NEUTRALIZER TOP AND BALL RETAINER REPLACEMENT:

ZIGGITY SYSTEMS INC. WWW.ZIGGITY.COM	FIELD FIX: SLOPE NEUTRALIZER		PART NR.:
	DATE: 1-17-06	REVISION:	GL1058

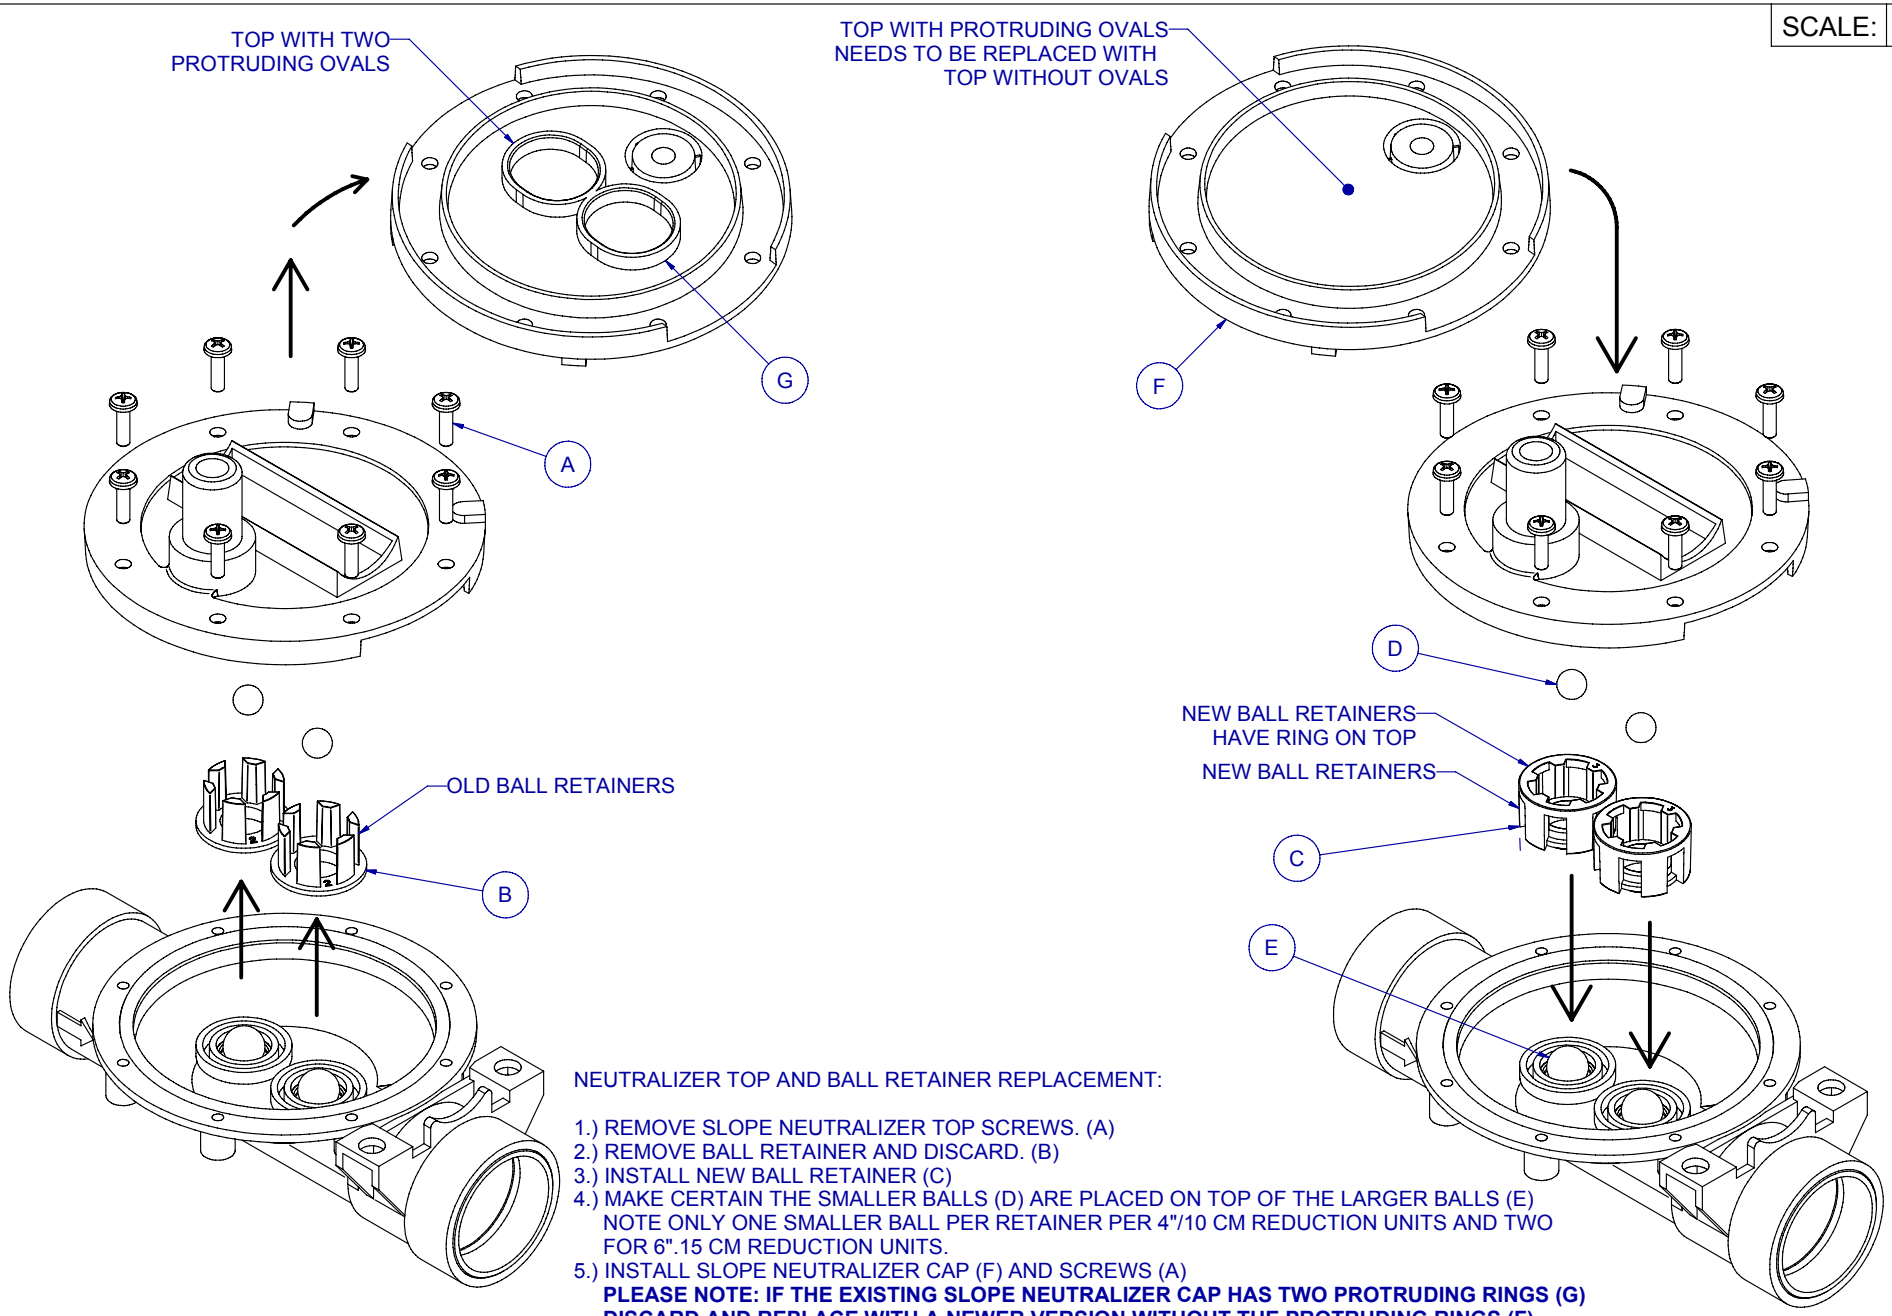
1.) REMOVE SLOPE NEUTRALIZER TOP SCREWS. (A)
2.) REMOVE BALL RETAINER AND DISCARD. (B)
3.) INSTALL NEW BALL RETAINER (C)
4.) MAKE CERTAIN THE SMALLER BALLS (D) ARE PLACED ON TOP OF THE LARGER BALLS (E) NOTE ONLY ONE SMALLER BALL PER RETAINER PER 4"/10 CM REDUCTION UNITS AND TWO FOR 6".15 CM REDUCTION UNITS.
5.) INSTALL SLOPE NEUTRALIZER CAP (F) AND SCREWS (A)
PLEASE NOTE: IF THE EXISTING SLOPE NEUTRALIZER CAP HAS TWO PROTRUDING RINGS (G) DISCARD AND REPLACE WITH A NEWER VERSION WITHOUT THE PROTRUDING RINGS (F)
